SUBJECT: DEMONSTRATION / DELIVERY HOLD - Safety Recall 15S25
Certain 2016 Model Year F-53 and F-59 Vehicles
Transmission Shift Cable Bracket Replacement

CERTAIN 2016 MODEL YEAR FORD F-53 MOTORHOME AND F-59 STRIPPED CHASSIS VEHICLES — TRANSMISSION SHIFT CABLE BRACKET REPLACEMENT

FIGURE 1

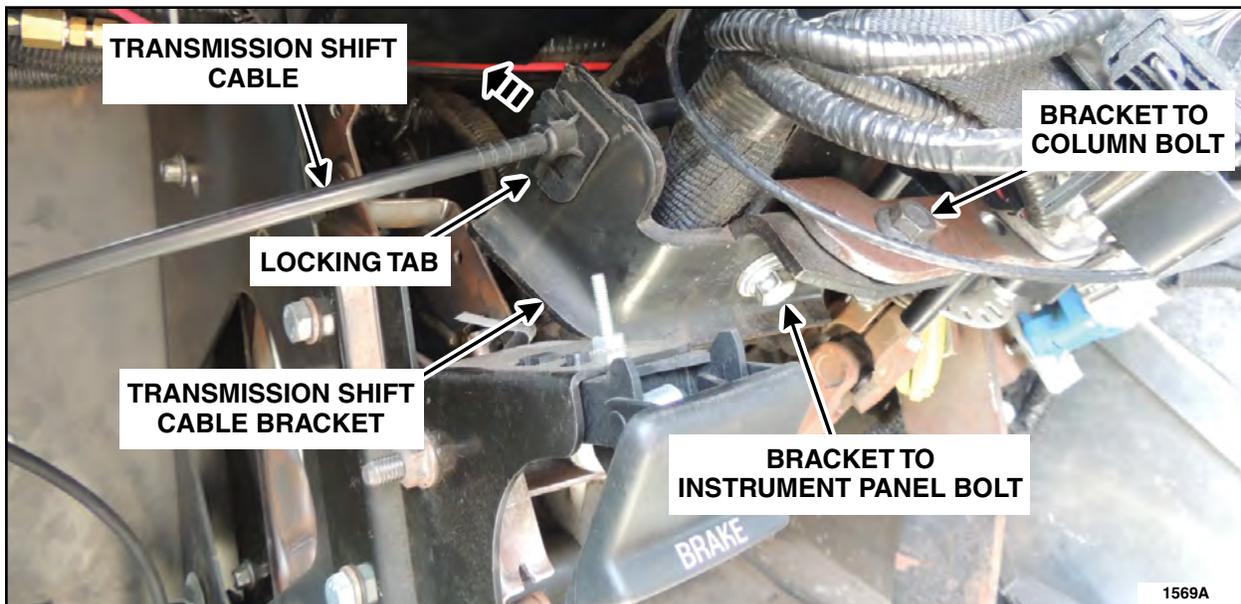
1. Remove the lower steering column trim/knee bolster panel as necessary to gain access to the lower steering column area. Refer to the Coach Builders Repair Manual for additional information if necessary.
2. Remove the transmission shift cable bracket. See Figure 1.
 - a. Carefully lift the locking tab and disconnect the transmission shift cable from the bracket.
 - b. Remove the two bolts and the transmission shift cable bracket.
 - When installing the bolts, torque to the following specifications:
 - Bracket to Column bolt to 36 lb.ft (48 Nm).
 - Bracket to Instrument Panel bolt to 21 lb.ft (28 Nm).

3. To install the *new* transmission shift cable bracket, reverse the removal procedure.
4. Perform the Selector Lever Cable Adjustment procedure. Please follow Workshop Manual (WSM) procedures in Section 307-05.
